Our Ref: KC2225/MS

28th January 2022

**Proposed Development of Curraghinalt Mine
Response to NIEA letter of 20th December 2021; Ref: AIL/2020/0105, AIL/2020/0106**

Figure 1: Inflows to Underground Mine from abstraction licence application and July 2020 water balance – groundwater model predictions, with highest total (used in abstraction licence application) highlighted by red circle

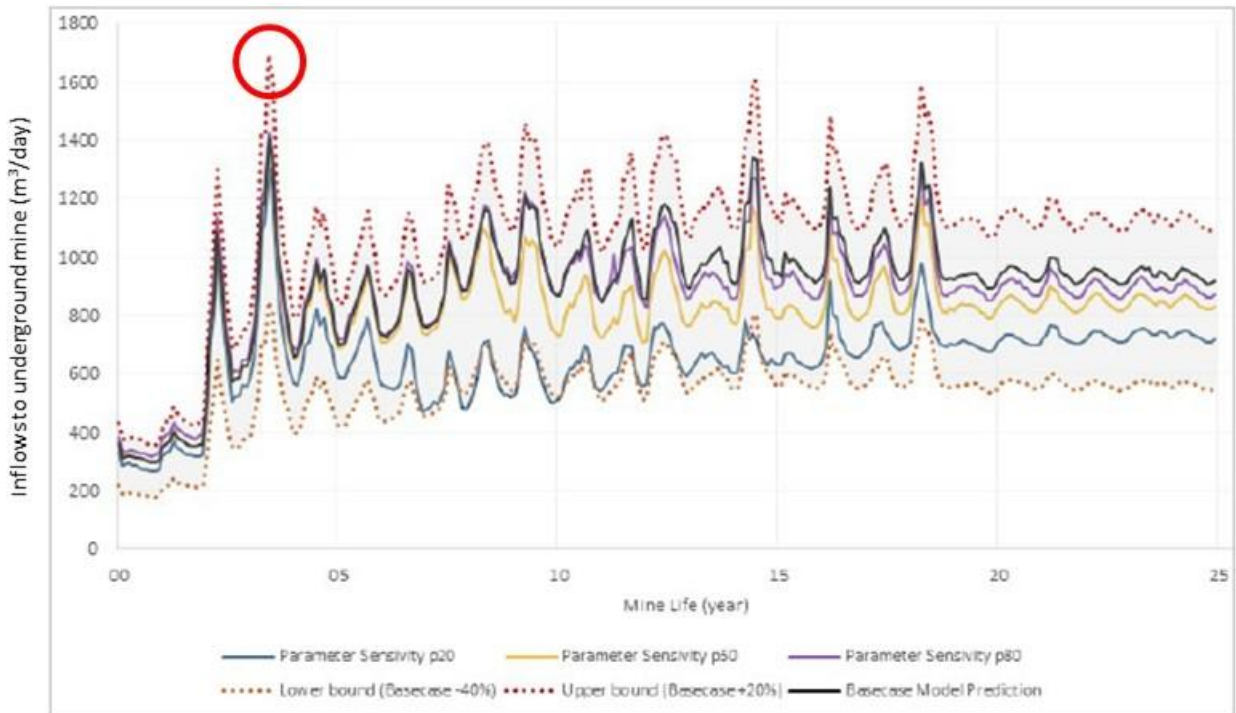
- 1. Please confirm the actual volumes proposed for abstraction for both applications AI/2020/0105 and AIL/2020/016. Please provide a detailed schematic drawing of the full proposal setting out clearly the volumes for abstraction, storage volumes and finally discharge. NIEA recognise that these details may have been submitted previously however a range of figures have been provided, as such the information provided in response to this information request will be considered the final volumes proposed for abstraction.**

Abstractions will vary month by month depending on the stage of the mine life and the rock type. The abstraction figure of 1,700 m³/day used in the application refers to the maximum value predicted from groundwater modelling of water flowing into the underground mine. The Environmental Impact Assessment (EIA) for the project included groundwater modelling which considered a range of climatic conditions and other model parameters, producing a range of predictions for water entering the mine workings. The range of values are summarized in Figure 1, which was provided within the Abstraction Licence application documents.

Figure 1 illustrates how mine water inflows and abstractions would vary through the life of mine. The value in the abstraction licence application is illustrated in Figure 1 with a red circle. The value in the abstraction licence is the maximum predicted volume of 1,700 m³/day (70.8 m³/hour or 19.7 L/s). Within the October 2020 Water Balance Report the groundwater modelling was updated. Following this update the maximum discharge reduced to 1,610 m³/day. We are content to retain the maximum discharge rate of 1,700 m³/day, as per the application, given the small difference (5%) in values.
